Permitting Decisions- Variation (substantial)

We have decided to grant the variation for Saltfleetby Wellsites operated by Angus Energy Weald Basin No.3 Limited.

The variation number is EPR/BJ3107XB/V002.

Angus En Figure 2: Proposed Site Layout (Production Phase) of the Saltfleetby B Well site
 Issued 22/03/2022 Page 8 of 81

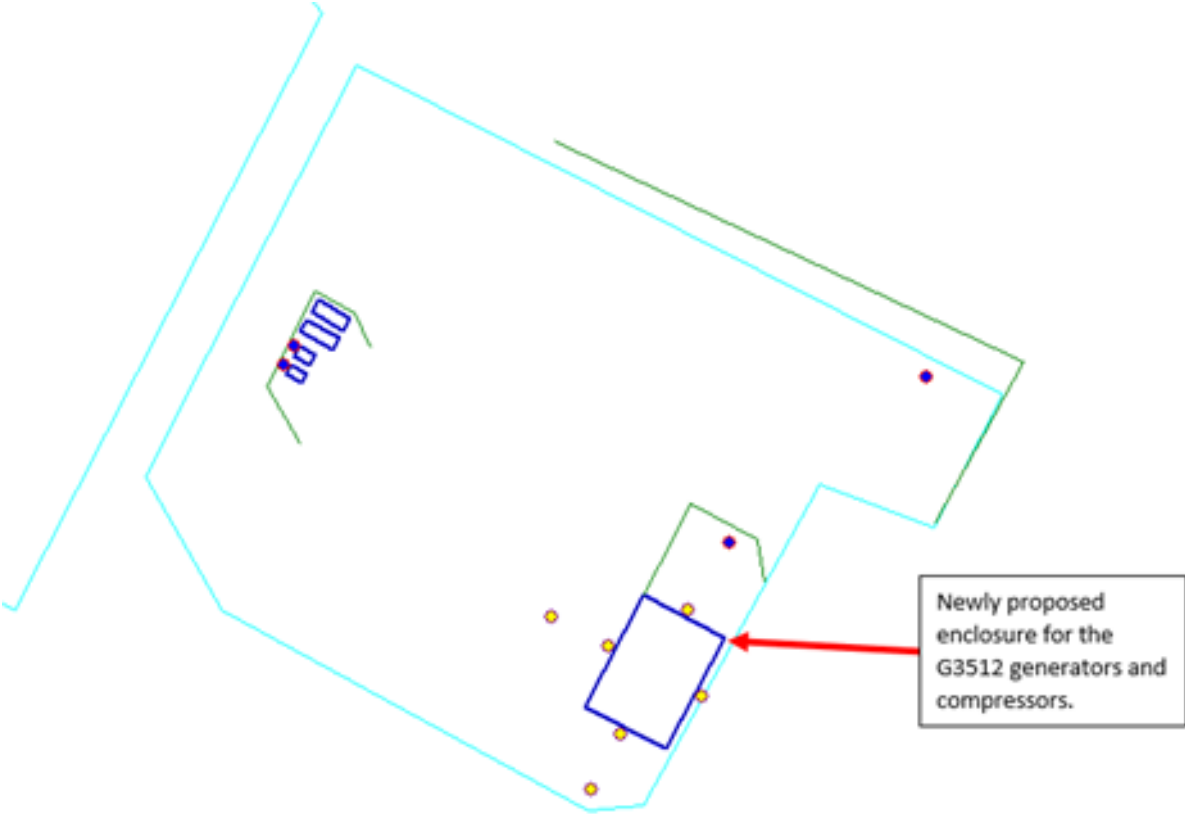
We confirmed that the acoustic barriers in the model are five metres above ground level at their location. The height and location should be included in the noise management plan (NMP), see below.

We agree with the conclusions drawn, that there is a risk of adverse impacts during the night at three locations along Saddleback Road. This is based on the design targets for the larger compressor enclosure being met and other mitigation measures are as specified in the NIA.

We confirm that the operator has proposed a large enclosure surrounding the G3512 compressor plant at the south end of the site. This has a design limit of 71 dB at 1 m from the enclosure. The pre-operational condition for a NMP includes this requirement.

The modelled barriers in the NIA (all at five metres) are shown as green lines in the drawing below:

We have also included a pre-operational condition for a NMP to be in place prior to commissioning of the new plant. This condition requires the NMP to include the three five metre high acoustic barriers and acoustic enclosures as noise predictions are based on these (see above). It also includes the required minimum sound reduction indices of the enclosures (for the engines) and muffler (for the exhausts) and the design target for the large enclosure housing the G3512 compressor equipment. The performance of this enclosure will be checked through on site measurements required by the NIA improvement conditions.
